PRODUCT CHANGE NOTIFICATION

ID-No.: 001250232

We would like to inform you about the change to the output terminals and the adjustment to the signal contacts on our PCC-4124-040-01:

PCC-4124-040-01

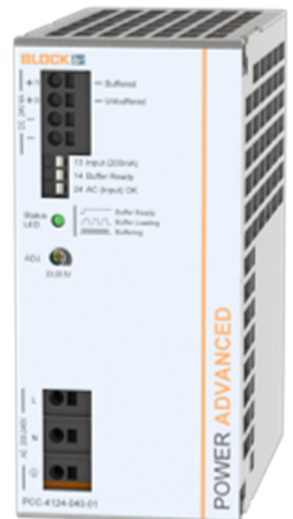
Regarding our PCC-4124-040-01 capacitive power supply, we are pleased to inform you that, instead of the previous two buffered outputs, there is now one buffered output and one unbuffered output. This makes the power supply significantly more flexible in its application. In addition, the PCC-4124-040-01 now also features 2 status contacts for the following function:

- 13 Input
- 14 Buffer ready
- 24 AC (Input) OK
